ACKNOWLEDGEMENT OF REQUEST BY OWNER FOR RECLASSIFICATION OF SITE FROM "UNSUITABLE" TO "PROVISIONALLY SUITABLE" UNDER 10 NCAC 10A .1948(c)

RE: Property located at 8800 Gilead Rd.
FILE: 4495A
PARCEL: 015 101 05 PO

MECKLENBURG COUNTY ENVIRONMENTAL HEALTH
SITE EVALUATION REPORT
SERIAL NUMBER 15338

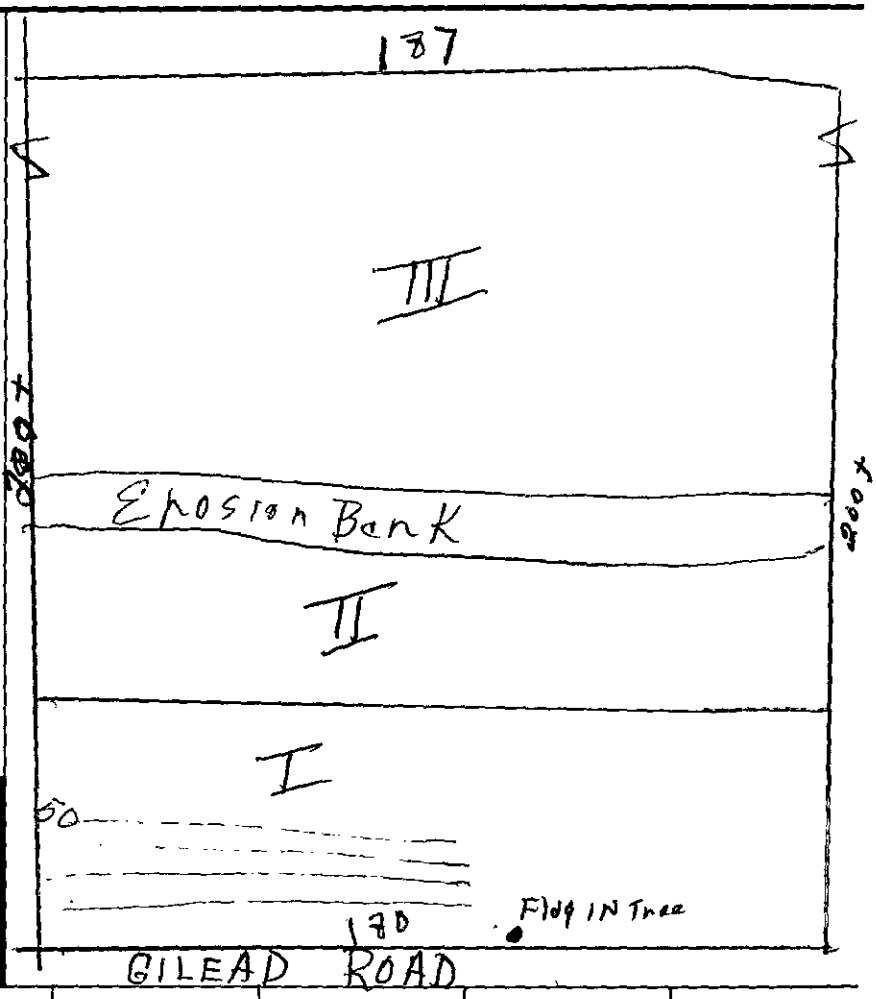
Revised Report. Lot Enlarged

Comments: (1) Start lines on Left Side of Lot And At The Road RofW. 2 Lift Station Required

PROPOSED PLOT PLAN

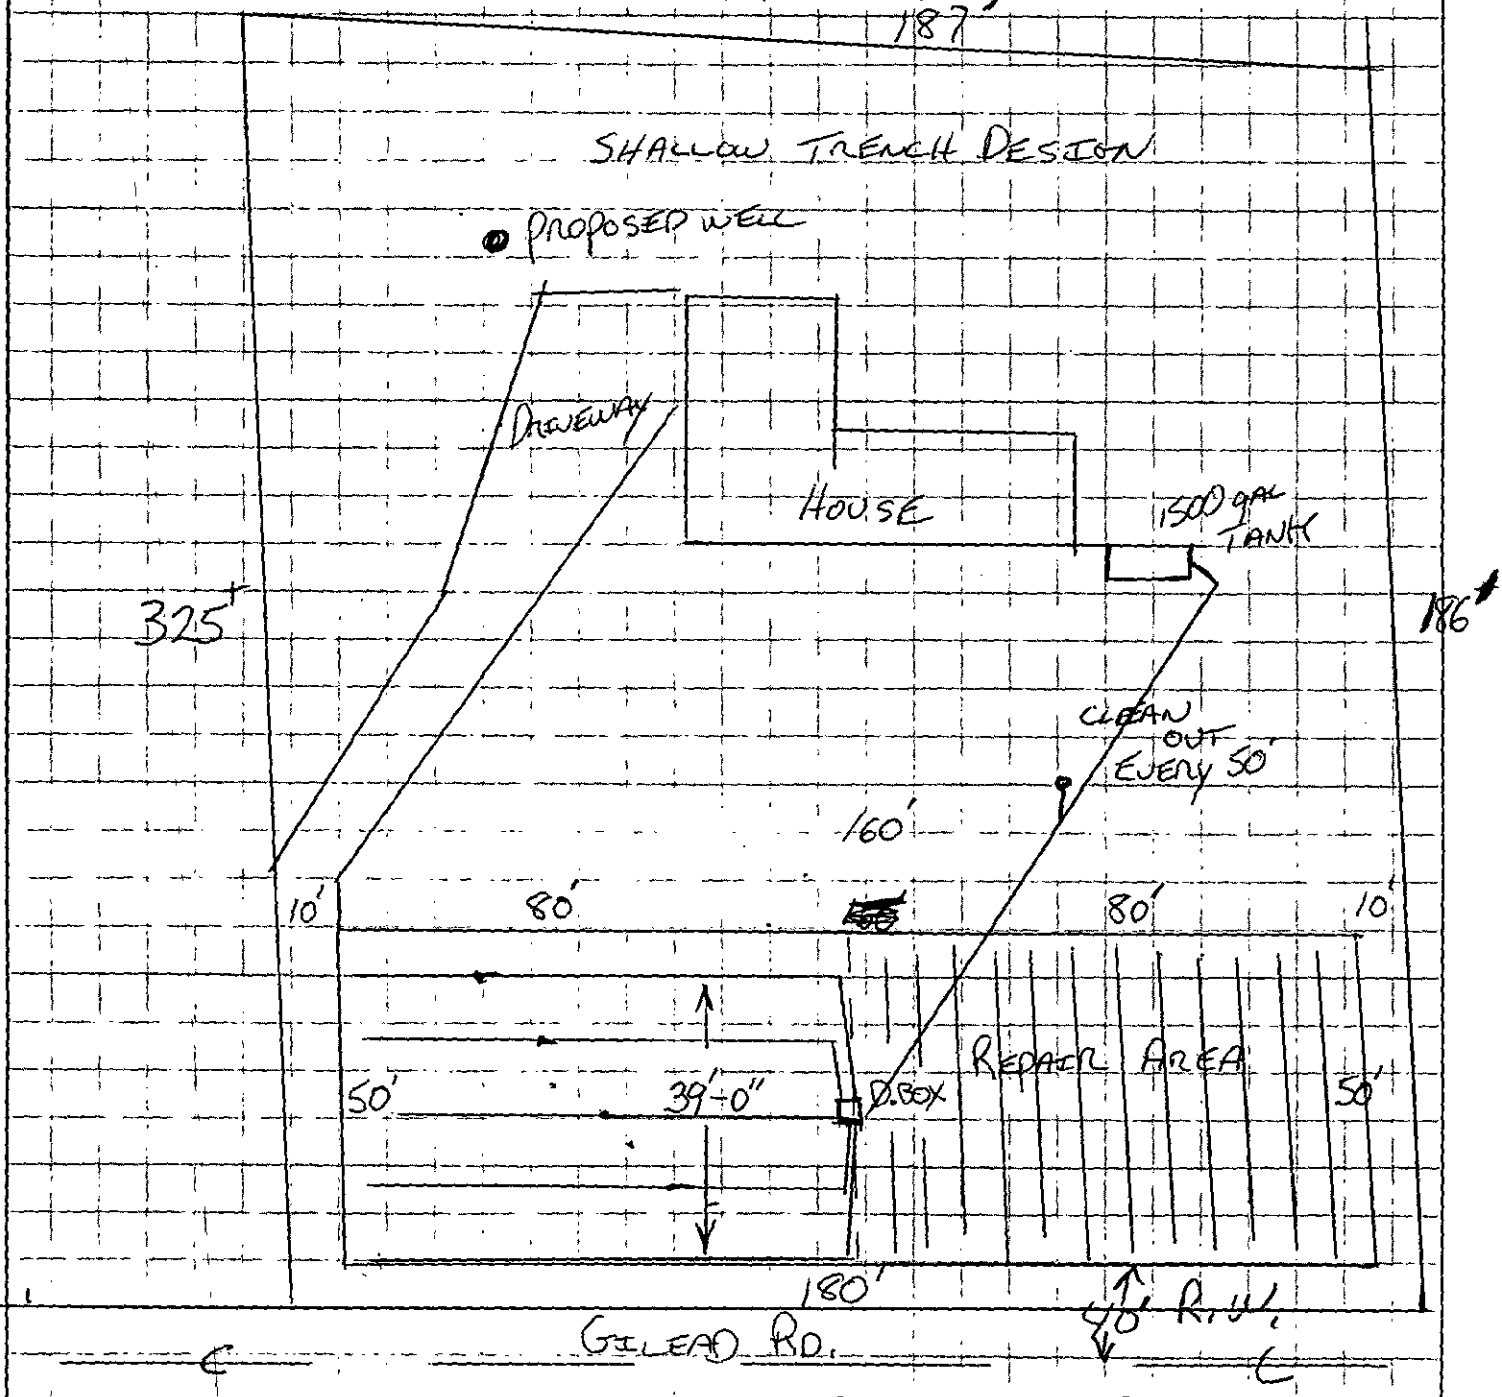
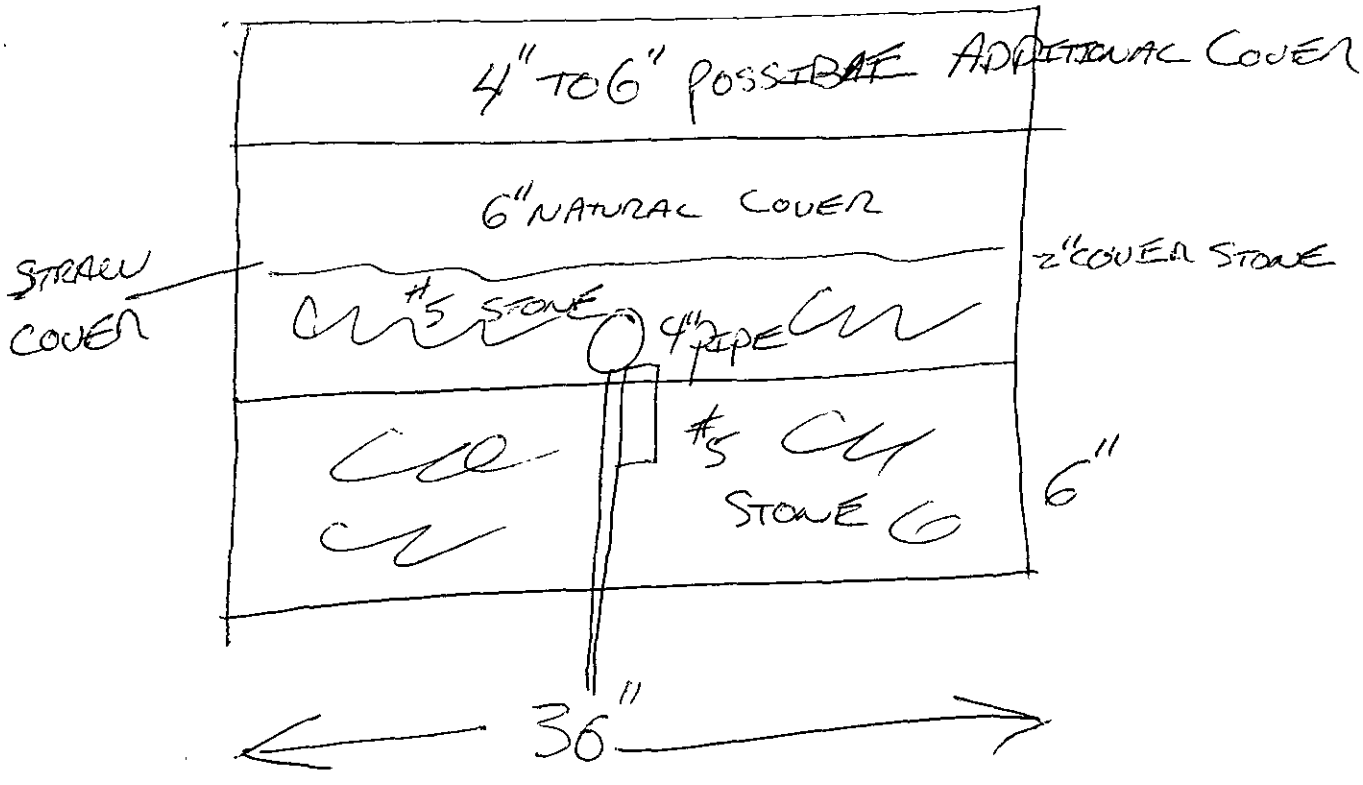
Receipt of your plans for a modified waste disposal system for the property referenced above is acknowledged.

Your plans for the modified system for the above property as submitted are approved. The well should not be located closer than 100 feet away from any part of the system or the repair area.

LOT SIZE HAS INCREASED
FROM 150' TO 180' AS OF 6-29-88'
AT FRONT OF LOT

MECKLENBURG COUNTY ENVIRONMENTAL HEALTH
SITE EVALUATION REPORT
SERIAL NUMBER 15174

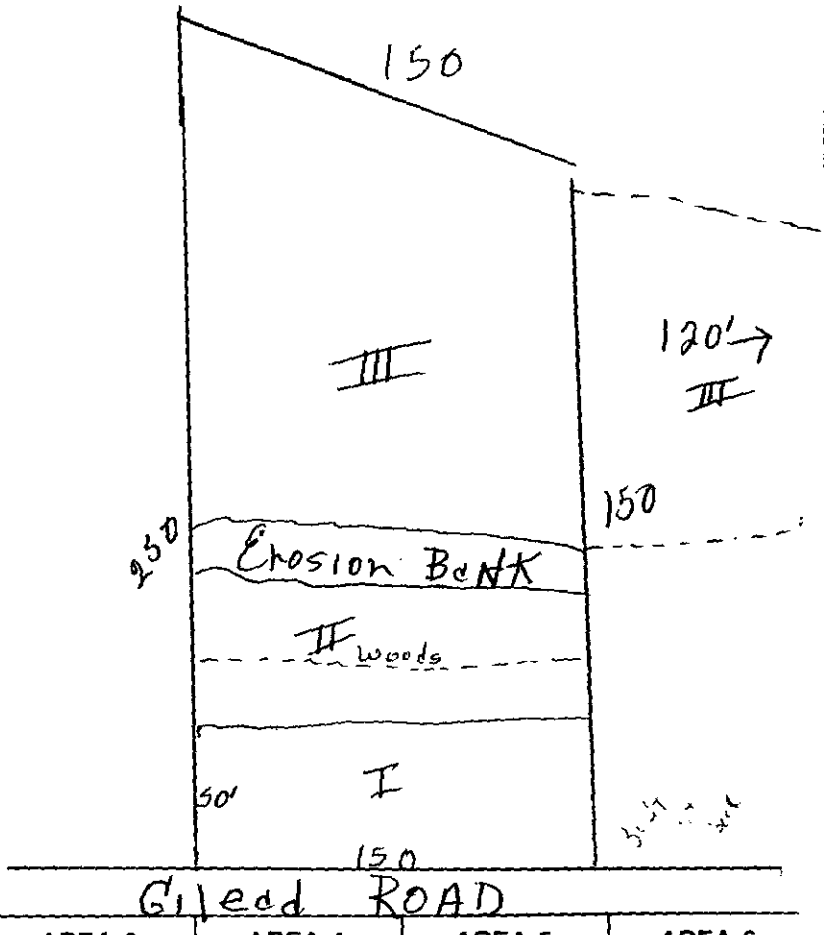
Comments: Lift Station will Be Required

This is An
Excellent one For
A shallow system
or A low pressure.
The Texture is better
Than Average, but
The depth is Short
By 6-8"

Discussed c Paul Gayle
6-26-85-
To submit shallow track
system - will attempt
repair area + ors. system
in front c/in good area -
Is willing to extend property
line - pump may be
required - will need to
short area — SD
